Plan Commission Staff Report
Department of Planning and Building
Town of McCordsville

Project: Villages at Brookside, Sections 14-15

Request: Petitioner is seeking approval of the Development Plan and Secondary Plat for Sections 14-15

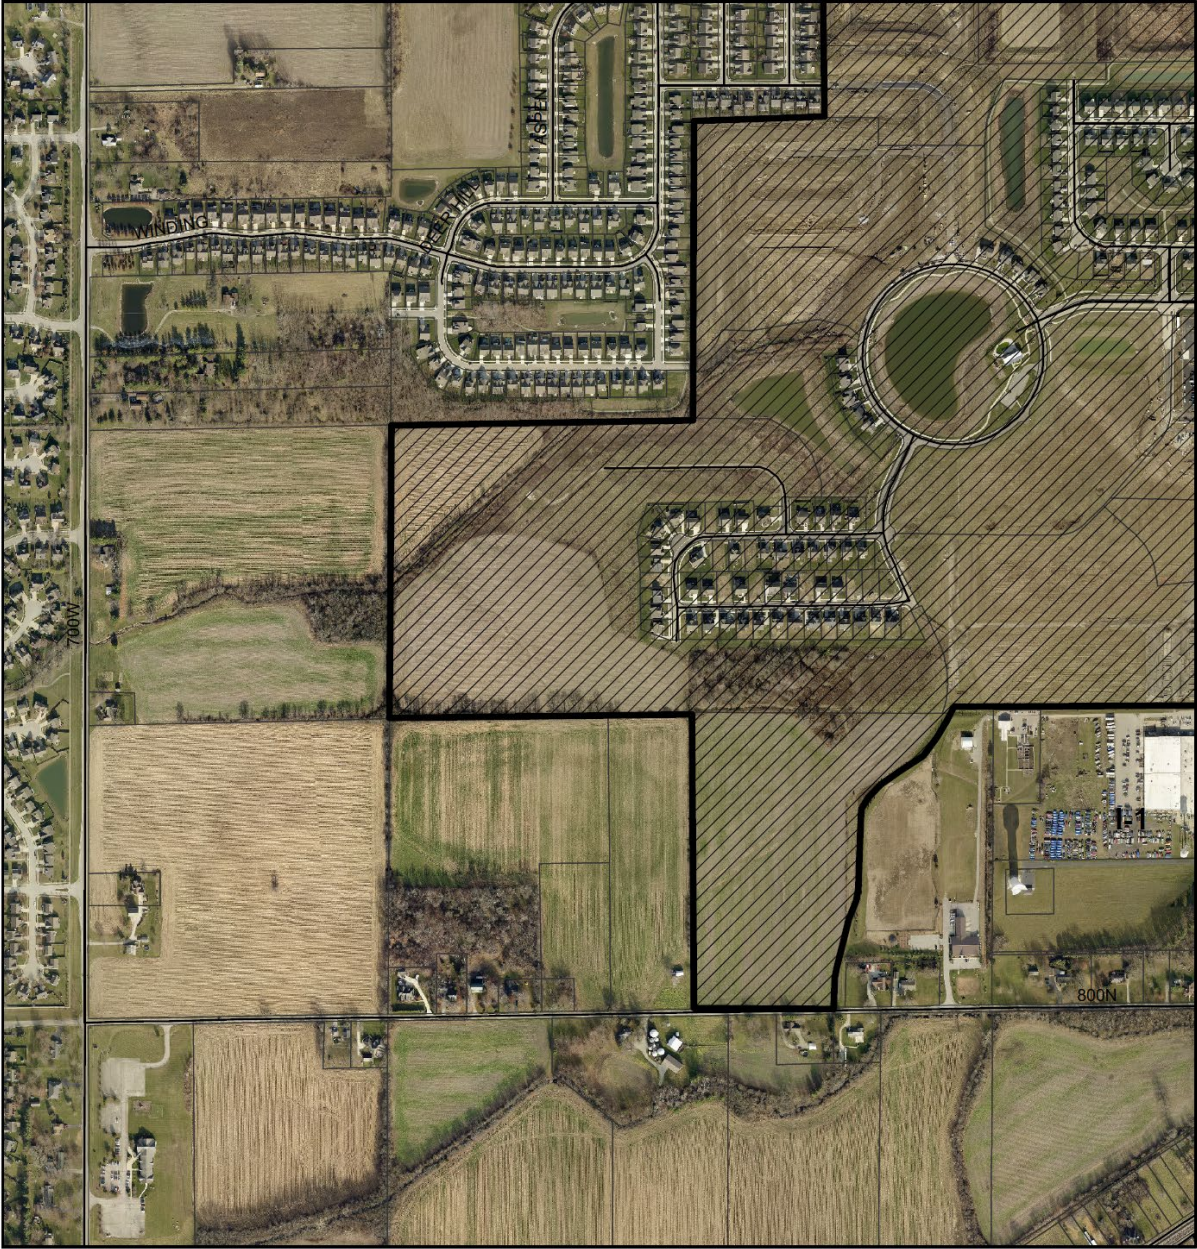
Landscaping: Each lot has must include 1 shade tree, 1 evergreen tree, and 8 shrubs. In addition, sod is required for front yards. *These plans are in compliance.*

Lot Count: The maximum number of residential units within Areas B & D of the Villages at Brookside is limited to 332. *These plans are in compliance.*

Street Lighting: Street lighting is required per the Town of McCordsville standards and has been provided on the plans. *These plans are in compliance.*

Open Space: Open Space is required in accordance with the Preliminary Development Plan. *These plans are in compliance.*
